## **SECTION 75W MODIFICATION (MOD 9) – MP08\_0238 1 DENISON STREET, NORTH SYDNEY**

This application has been prepared by Ethos Urban on behalf of Winten Property Group, pursuant to Section 75W and Clause 12 of Schedule 6A of the *Environmental Planning and Assessment Act, 1979* (EP&A Act) seeking amendment to Project Approval MP08\_0238 relating to the approved commercial building at 1 Denison Street, North Sydney (the site).

**Figure 1 – Comparison of approved (top) and proposed (bottom) Level 1 floorplate**

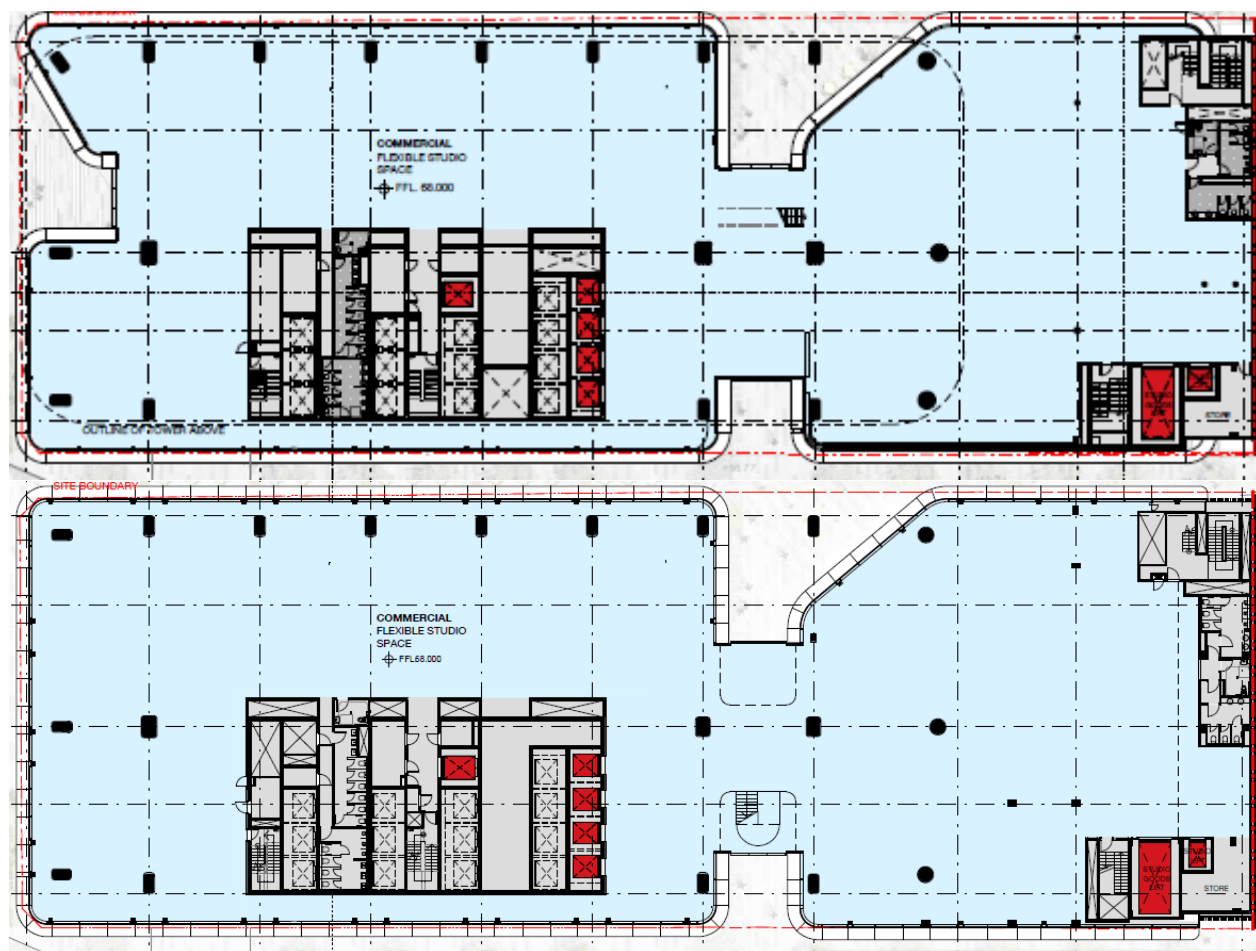
- **Regularisation of podium levels:** This application seeks to amend the retail floorplates at ground and mezzanine levels, and commercial floorplates at Level 1 and Level 2 to provide a regular floorplate and continuous built form that reinforces the street wall on the Spring Street frontage. A comparison of the approved Level 1 floor plate and the proposed Level 1 floorplate is provided at **Figure 1** for reference.
